## TLE986xQX Family - BF-Step

## TLE987xQX Family - BF-Step

This document lists the errata of the TLE986xQX family and the TLE987xQX family.

Figure 1 Example IROM settings for the TLE9871QXA20

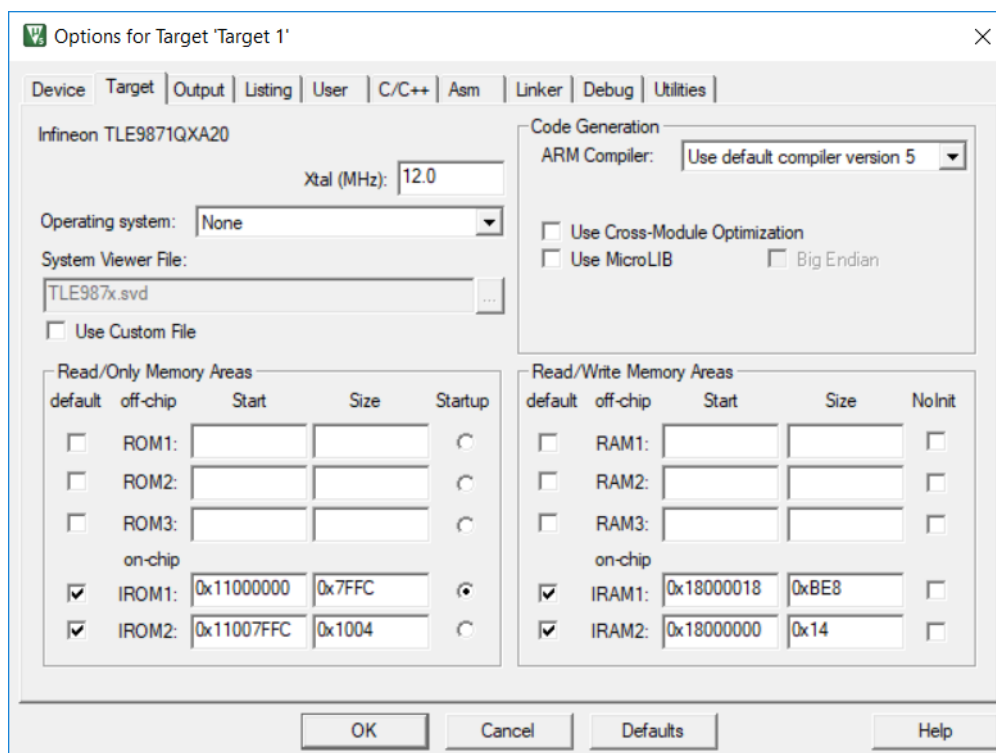
The function USER\_NVM\_ECC\_CHECK uses for its operation 32 bytes on the user stack plus 1 byte in user RAM at address 0x18000015, this is not clearly specified in the BootROM User Manual.

Adjust the project IRAM settings to exclude this address from the RAM area usable by the linker. In order to maintain memory alignment a hole of four bytes, from 0x18000014 to 0x18000017 is recommended. **Figure 1** displays an example for the TLE9871QXA20. **Table 3** lists the recommended IRAM settings for each device.

Fix with next user documentation update.

Figure 5 Register view of implemented SHPR2 register

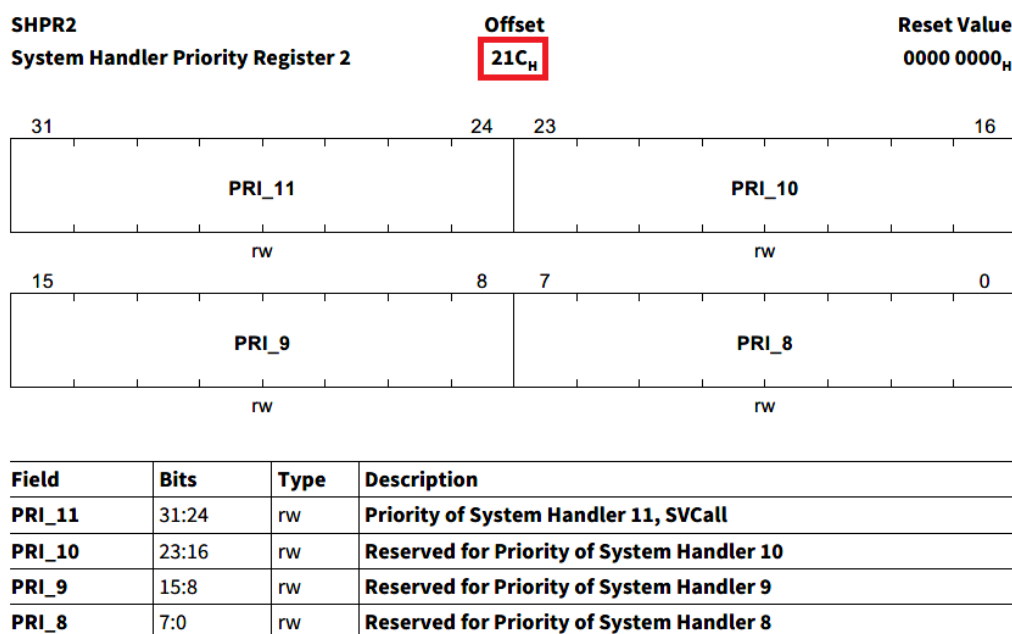
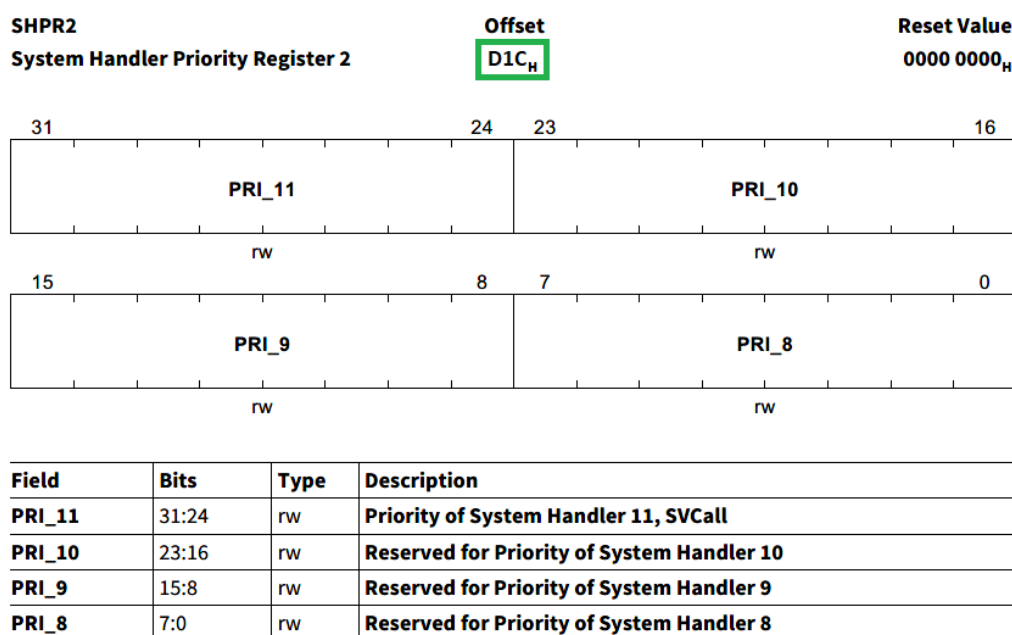
The address of the register SHPR2 is specified wrongly.

The implemented address for the register SHPR2 is 0xE000ED1C.

Fix with next user documentation update.
